**MAJOR PROJECT ASSESSMENT**  
**University of Technology Sydney**  
**Faculty of Science Building**  
**Major Project Application**  
**MP 09\_0213**

Director-General's  
Environmental Assessment Report  
Section 75I of the *Environmental Planning  
and Assessment Act, 1979*

June 2012

**Figure 6: Thomas Street elevation (Project Application)**

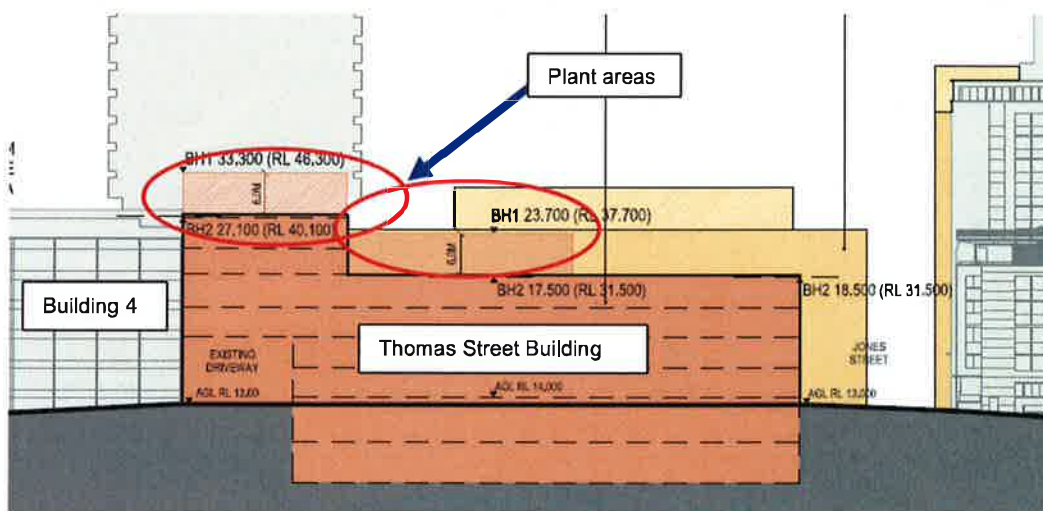
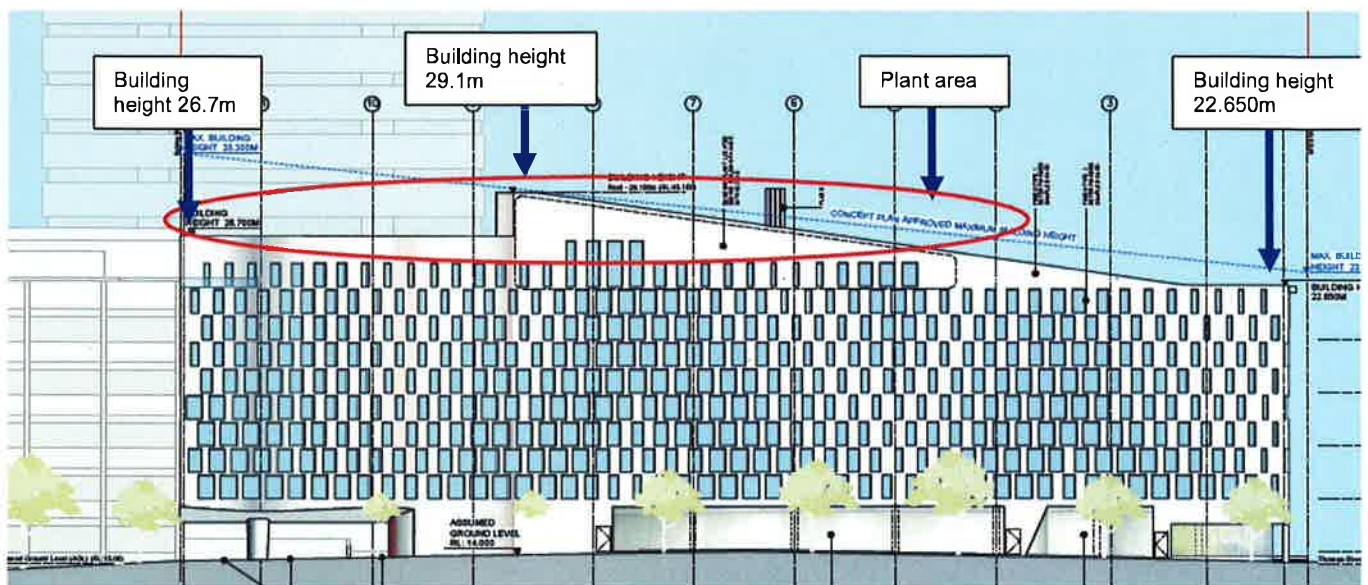
The building envelope in the Concept Plan incorporates a taller element (27.1m high) above the driveway that reflects the height of the adjoining building, Building 4. The building envelope steps down to a four storey scale with a height of 17.5m which continues to Jones Street. The building envelope is approximately 1m higher at Jones Street due to the fall in the footpath levels.

The Faculty of Sciences building in the Project Application has a height of 26.7m where it adjoins Building 4 and extends across the driveway, which is consistent with the approved Concept Plan. However, the building then steps up (not down) to its maximum height of 29.1m and then gradually slopes down to the Jones Street corner where it has a height of 22.650m (instead of 18.5m) and does not strictly comply with the Concept Plan.

The proposed design incorporates a 6m high service plant zone on top of the building envelope. The plant area has been integrated into the design of the building by roofing this area. The design includes glazing to this level on the Thomas Street elevation so the area reads as another floor in the building rather than roof plant. The additional height incorporates the roof plant and services, which are concealed from view and integrated with the overall design of the building.

The architectural design of the building is of high quality and is supported by the City of Sydney. The additional height on the Jones Street elevation does not result in any adverse amenity impacts on adjoining properties, in terms of bulk, scale, solar access or views. Therefore, the proposed height and form of the building is acceptable.

Figure 7: Landscape plan

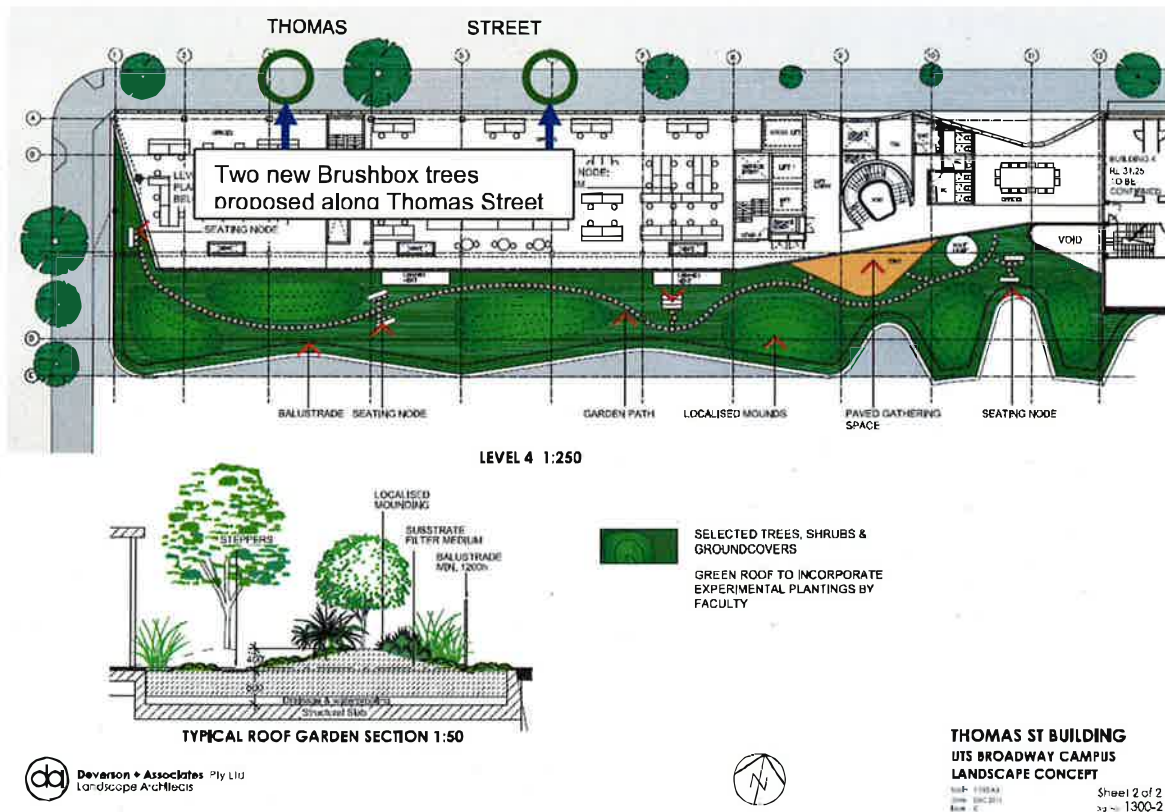
Council supports the rooftop landscaped area but suggested that further detailed plans be prepared to address planting specifications, construction and stormwater management. Conditions to this effect are included in the recommendation.

Figure 8: Solar access to Alumni Green

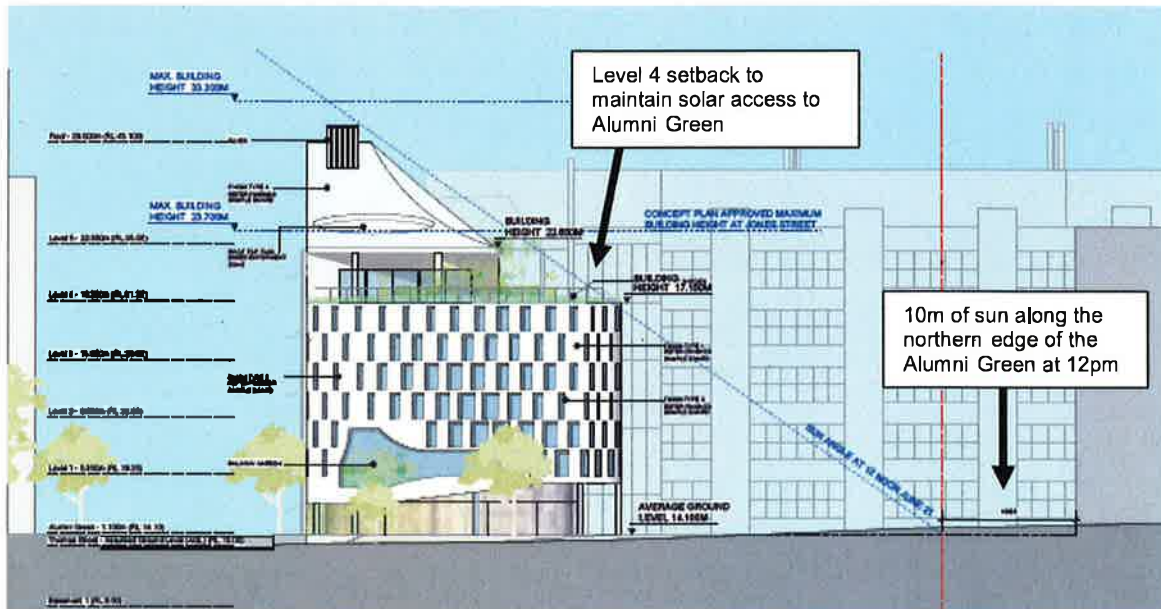
As noted earlier in Section 5.1.2, the proposed height and envelope of the Faculty of Science building differs from the approved Concept Plan. The shadow diagrams submitted with the application illustrate that a 10m wide strip of sunlight is provided along the edge Alumni Green from 9am to 12pm at mid-winter. By 1pm, a 5m wide strip is achieved and by 2pm the Alumni Green is completely overshadowed. Therefore, the proposal is non-compliant between 12pm and 2pm.

The design does not achieve a full hour of sunlight to comply with the 10m wide strip of sunlight along the northern edge of Alumni Green at 1pm at mid-winter. Partial compliance is achieved at 12:30pm where only a 5m wide strip of sunlight is achieved along the northern edge of Alumni Green. However, the proponent has designed the topmost floors of the proposed building to be setback from the southern elevation as illustrated in Figure 8 so the non-compliance with the height and envelope does not increase shadowing of the Alumni Green.

Council's submission noted that the solar access to Alumni Green does not strictly comply with the Concept Plan as outlined above but accepts that the combination of Alumni Green and the rooftop landscaped area will provide an appropriate level of privately and publicly accessible open space for the site. The Department supports the proposed height of the Faculty of Science building and considers that an adequate level of solar access is achieved to Alumni Green, particularly considering the scale of development that surrounds the site.
